NEW ROTC BUILDING

South Brunswick High School
Southport, North Carolina
BMG Project No. 2019241.00

ADDENDUM NO. 4

SOUTH BRUNSWICK HIGH SCHOOL - NEW ROTC BUILDING

ROTC FLOOR PLAN - CANOPY LIGHTING

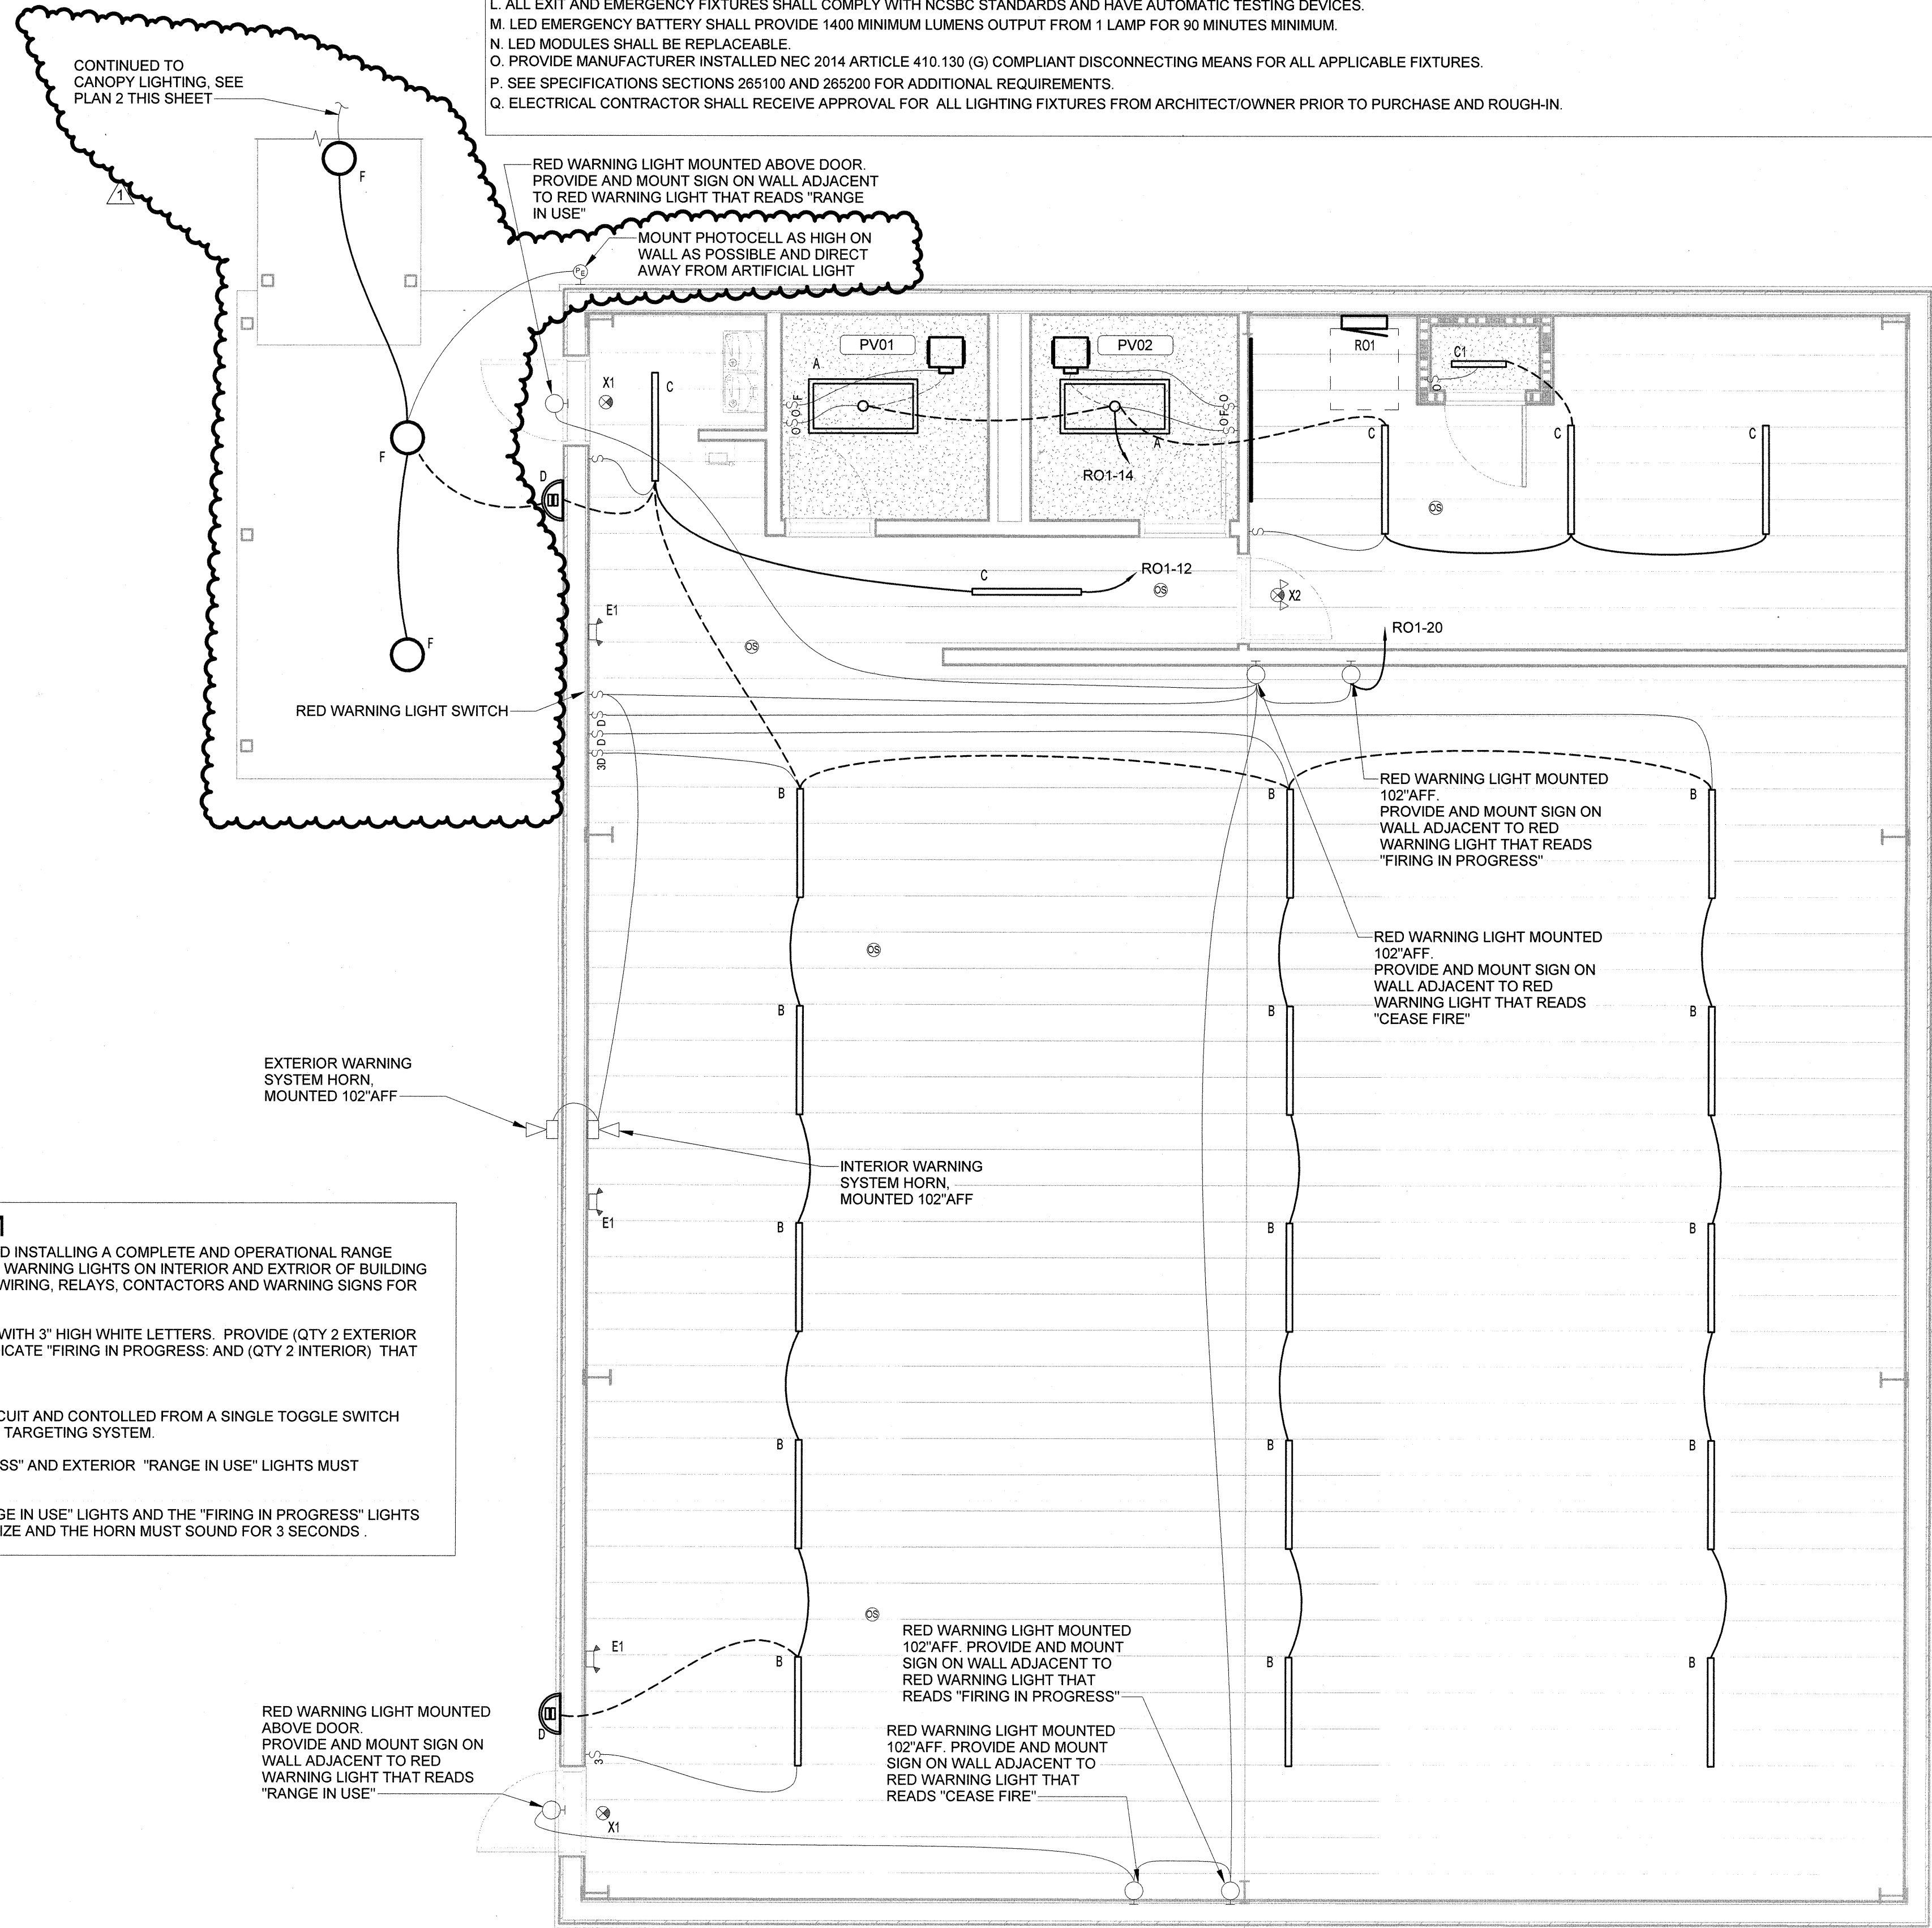
- a. Sheet E201 - ROTC Floor Plan - Lighting: **DELETE** and **REPLACE**. Delete Sheet E201, dated 08/27/2020 and replace with Sheet E201, dated 09/21/2020. Lighting has been added to the canopy. See Sheet E201 attached to the end of this Addendum.
